# Freeway Park Improvements

## Meeting Summary

**April 2, 2020**

Concept Design

Image 2: Proposed lighting elements (left) & Wayfinding elements (right)

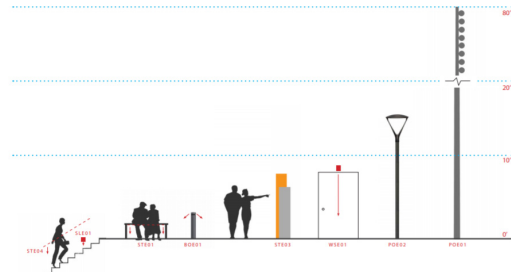
While the Commission appreciated the variety of proposed lighting elements, commissioners were concerned with the lack of detail provided to address the hierarchy of lighting elements, specifically with how lighting relates to circulation and access. The Commission recommended the team use the most prominent lighting element(s) to highlight main pathways through the park, while other lighting elements have a secondary, supportive role in the overall lighting plan. The SDC also recommended the project team provide a canopy plan to show how the tree canopy will evolve over time.

1. Consider using the most prominent lighting element(s) to highlight main pathways through the park, while other lighting elements play a secondary, supportive role in the overall lighting plan

Image 3: Proposed specific area plans

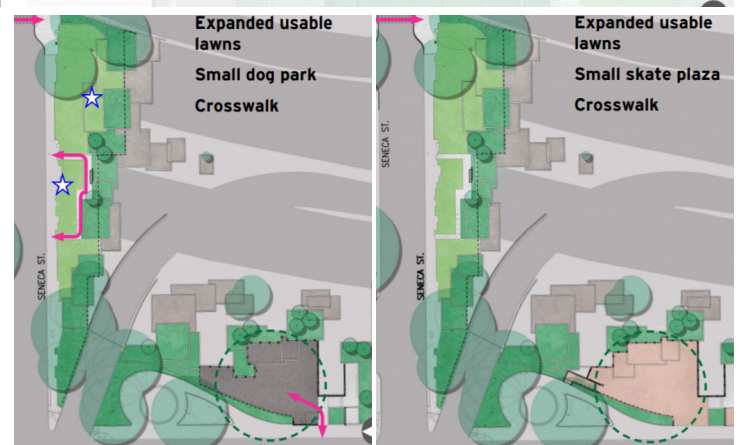
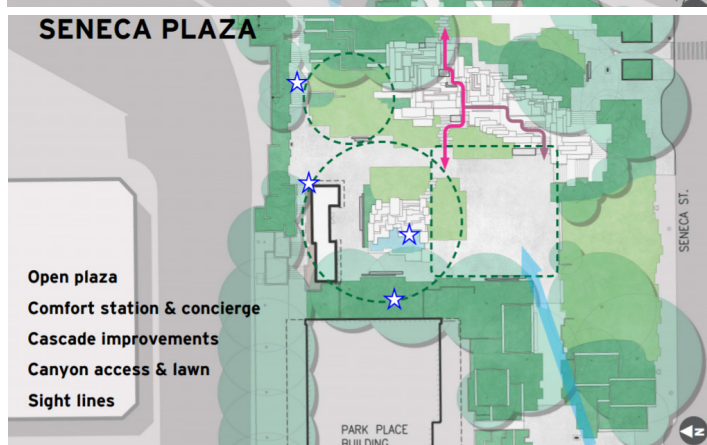
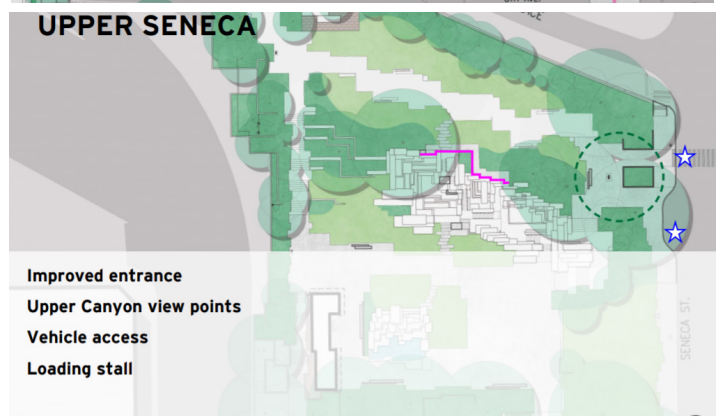
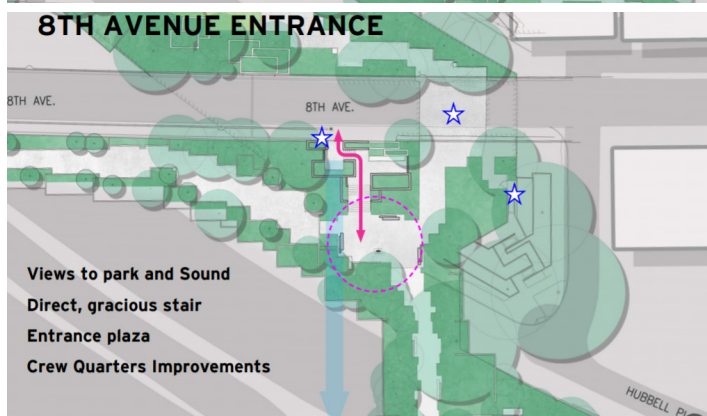
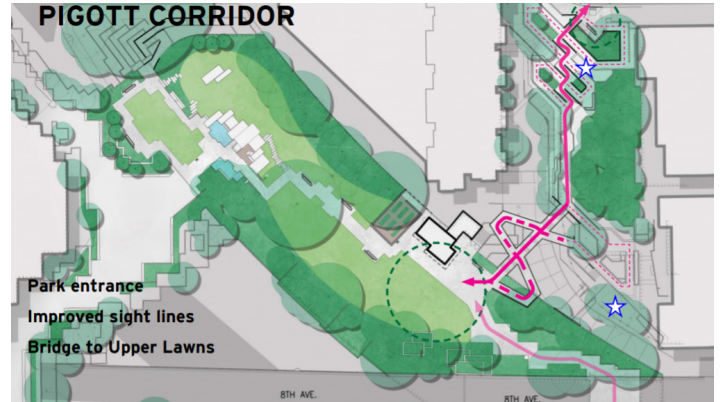
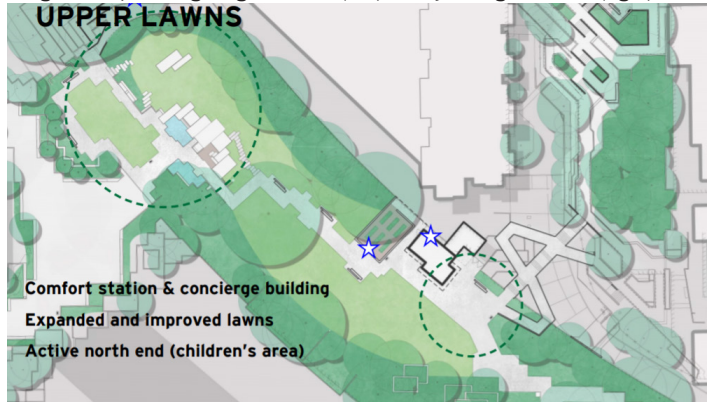
The SDC commended the project team for the detailed design proposals for each park area. Specifically, commissioners commended the team for creating recognizable destinations, providing a space for park users to explore, and for improving access and circulation within and between park areas. Commissioners also appreciated the detail provided in enhancing specific entrances, specifically the entrance at 8th Ave as well as

improvements made to the Pigott Corridor. Although not located within the park, The Commission recognized the Pike St entrance as a main gateway into the park, specifically for the Capitol Hill Neighborhood. The Commission recommended the project team coordinate with the WSCC to explore ways to improve the Pike St entrance and corridor connecting it to the Upper Lawns and Convention Center Plaza area.

The SDC appreciated the design proposal for the Lower Seneca Plaza. The Commission agreed that the expansion of the plaza area would provide additional space for programming. Commissioners also appreciated the proposal to revitalize the Canyon Fountain and to increase access through the fountain between the Upper and Lower Seneca Plazas. The Commission then commended the project team for their proposal to provide a concierge and comfort station along the northern edge of Seneca Plaza as well as between the Upper Lawns and Pigott Corridor area.

The Commission appreciated the project team's overall approach for the improvement of the Box Gardens, but recommended the project team think about the box gardens themselves as artistic elements, cautioning the project team from using art in a way that would reduce or compete with the experience and visibility of the Box Gardens. The SDC recommended the project team continue to think about where it would be appropriate to locate art within the park. The Commission then recommended the project team continue to explore programming around the Box Gardens that will meet the needs of the community while also serving as a way to attract new user groups to the park. Several commissioners thought that programming such as the proposed skate plaza could be used to draw additional user groups. The Commission then recommended the project team consider long term operation needs for proposed programming.

2. Consider providing a canopy plan to show how the tree canopy will evolve over time and overlay with lighting approach.
3. Coordinate with the WSCC to explore ways to improve the Pike St entrance and corridor connecting it to the Upper Lawns and Convention Center Plaza area

Image 4: Proposed option for comfort station on Seneca Plaza (left) and Upper Lawn (Right)

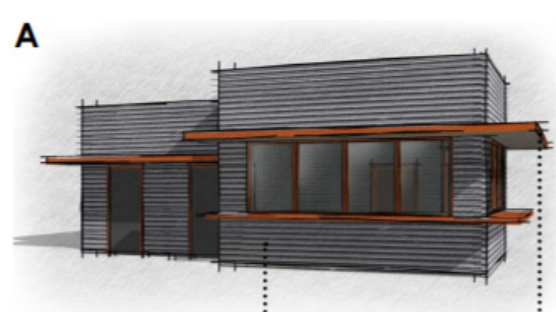
Commissioners discussed the proposed materiality of the buildings as it relates to the existing landscape design. The Commission appreciated the similarity between proposed materials and materials used in the original park design but cautioned the project team from designing the building to make it appear as if it were a part of the original park design. The Commission recommended the team use architectural features and materials that would serve as an extension of the landscape design and take cue from the boldness of the original park materials while also distinguishing it from the original park design, especially if the team plans to apply for the park to be designated as a City Landmark. The SDC recognized the comfort stations as being integral to the overall programming and recommended the project team provide additional information about access and the hours of operation for the proposed comfort stations. The Commission encouraged the team to think about how partnering organizations, such as Freeway Park Association, can help with funding for the construction and ongoing operations of the comfort stations.

4. Consider architectural features and materials for the proposed concierge and comfort stations that will serve as an extension of the landscape design and take cue from the boldness of the original park materials while also distinguishing it from the original park design

5. Provide additional information about access and the hours of operation for the proposed comfort stations.
6. Consider viewing the box gardens themselves as artistic elements; refrain from using art in a way that would reduce or compete with the experience and visibility of the Box Gardens
